Our ref: 104878-PEF-ZZ-XX-CD-RP-000600
Planning ref: 2022/0528/P

This note is in response to the initial LLFA response provided by Camden Council, dated 8th March 2022, in relation to the planning application for a site at The O2 Centre, Finchley Road.

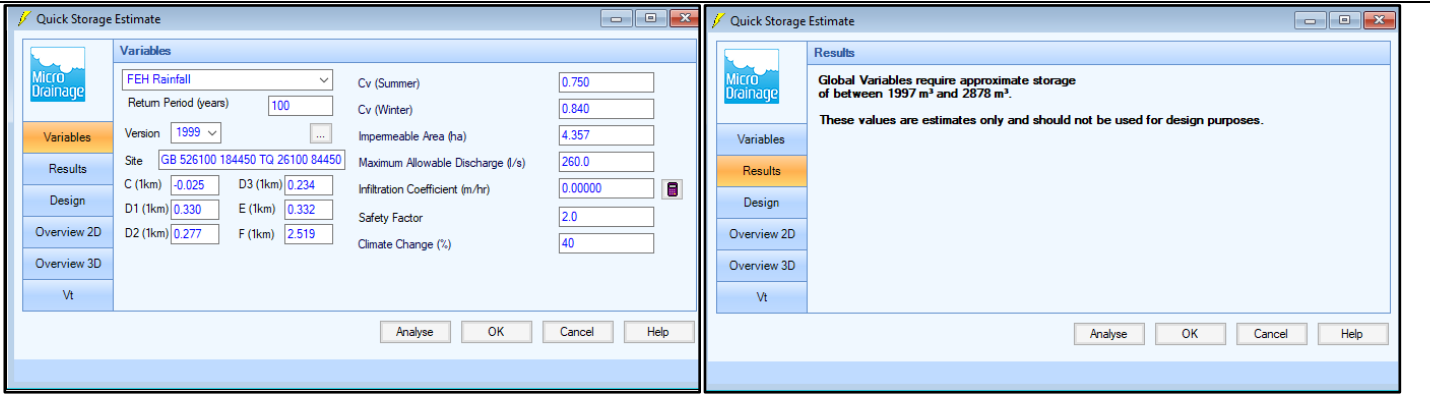
Justifies why rainwater harvesting is not proposed for the development.

Due to the high-rise nature of the development, the supply:demand ratio is disproportionately weighted to demand over supply. Calculating rainwater harvesting systems comprises the following steps (as set out in BS EN 16941-1:2018)

Step 1 – Calculate supply (yield)

Use average rainfall intensity and roof area to calculate potential rainwater supply to be calculated site-wide:

$$Y_R = 24,016 \times 653 \times 0.5 \times 0.9$$

$$Y_R = 7,057,101 \text{ l/yr or } 19,334 \text{ l/day (19.334m}^3\text{)}$$
